# Access Compliance Report

## Public Rights-of-Way

Intersection ID: 10158	Main Street: MULBERRY_CHURCH_RD	Cross Street: TUCKASEEGEE_RD	Location: NE
ADA ID: A9C7BF9F102C	Ramp Type: Perp	Initial Pass/Fail: Fail	Overall Compliance: No
		Severity Score: 30

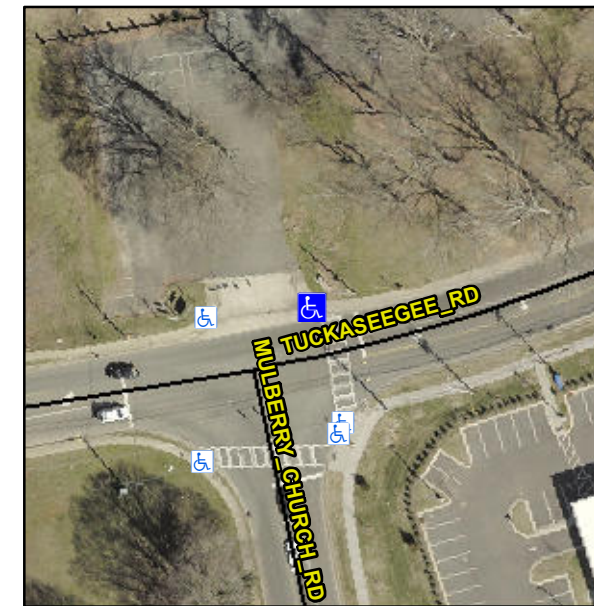
**Not Found, R304.5.1, R304.5.3**

Compliance	Description	Data	Compliance	Description	Data
N/A	Ramp Length (in)	60.0	Yes	Ramp Slope (%)	5.7
No	Ramp Width (in)	34.0	No	Ramp XSlope (%)	6.0
N/A	Flare Type LT	N/A	N/A	Flare Type RT	N/A
N/A	Flare Slope LT (%)	N/A	N/A	Flare Slope RT (%)	N/A
N/A	Flare Traversable LT?	N/A	N/A	Flare Traversable RT?	N/A
N/A	Landing Length (in)	N/A	N/A	DWS Provided?	N/A
N/A	Landing Width (in)	N/A	N/A	DWS Contrast?	N/A
N/A	Landing Slope (%)	N/A	N/A	DWS Length (in)	N/A
N/A	Landing X Slope (%)	N/A	N/A	DWS Full Width?	N/A
N/A	Landing Curb? (Y/N)	N/A	N/A	DWS Offset (in)	N/A
N/A	Shared Landing?	N/A			
N/A	Gutter Ponding?	N/A	N/A	Gutter Slope (%)	N/A
N/A	Gutter Lip Ht (in)	N/A	N/A	Gutter X Slope (%)	N/A
N/A	Painted X Walk1?	No	N/A	Painted X Walk2?	N/A
	X Walk 1 Direction	To S		X Walk 2 Direction	N/A
N/A	X Walk 1 Width (in)	N/A	N/A	X Walk 2 Width (in)	N/A
	X Walk 1 Slope (%)	5.1		X Walk 2 Slope (%)	N/A
	X Walk 1 X Slope (%)	1.1		X Walk 2 X Slope (%)	N/A

**Remove & Replace Entire Ramp.**
